Park Street Contraflow – Safety assessment and proposed actions

Concerns raised by community members & traffic engineering assessment

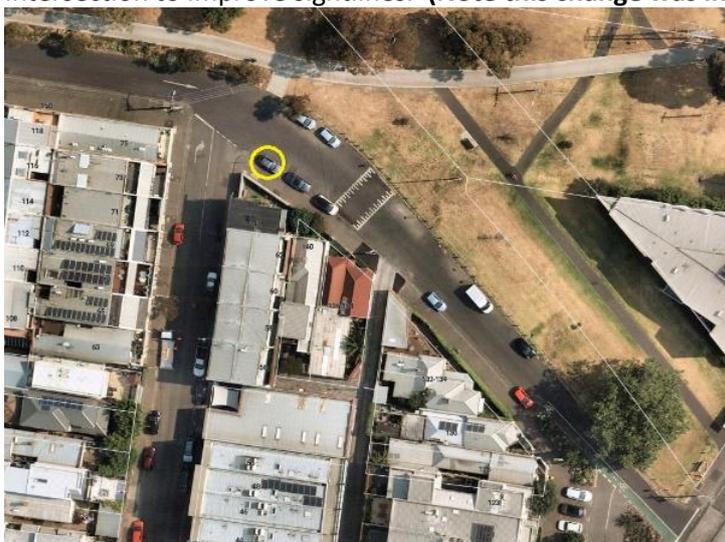
Risks associated with cars illegally travelling against the one-way

Officer comment: This issue can occur in any one-way situation and not the result of a contra-flow lane. Existing One Way/Turn Ban/Wrong Way Go Back signs are adequate. Additional signage (shown right) will be implemented along Park Street to clarify the nature of the contra flow lane and where road user needs to position themselves.

Confusion about who has right-of-way at the Brunswick St North & Rae St intersections.

Officer comment: BSN and Rae Street priority are different at Park Street. In BSN, cyclists on Park Street need to give way to traffic on BSN. On Rae Street, all traffic (including contra flow cyclists) have priority.

Additional signage will be installed to further clarify right-of-way.

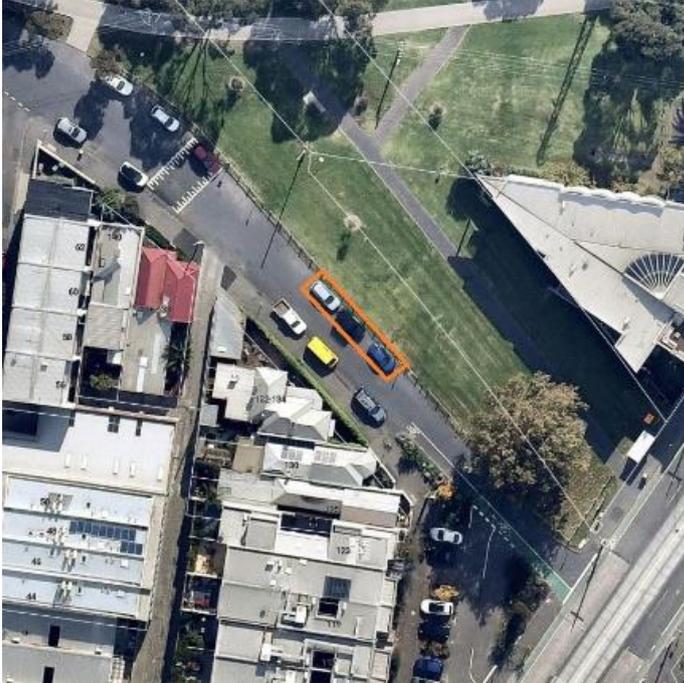
If the trial is successful at attracting high volumes of cyclists, it is highly recommended that three parking spaces on the north are removed to reduce the bottleneck. At expected cyclist volumes the existing layout appears to acceptable, however this should be monitored as part of the trial.

- 4 Add an additional sharrow to the road between the three car spaces on the north and the car spaces on the south at the identified “pinch point”.
- 5 Monitor cyclist volumes and reported near misses and/or crashes over the course of the trial. If there are higher than expected cyclist volumes, or safety issues identified, it may be recommended to remove the three car parking spaces identified below, and to further extend the delineated bike lane:
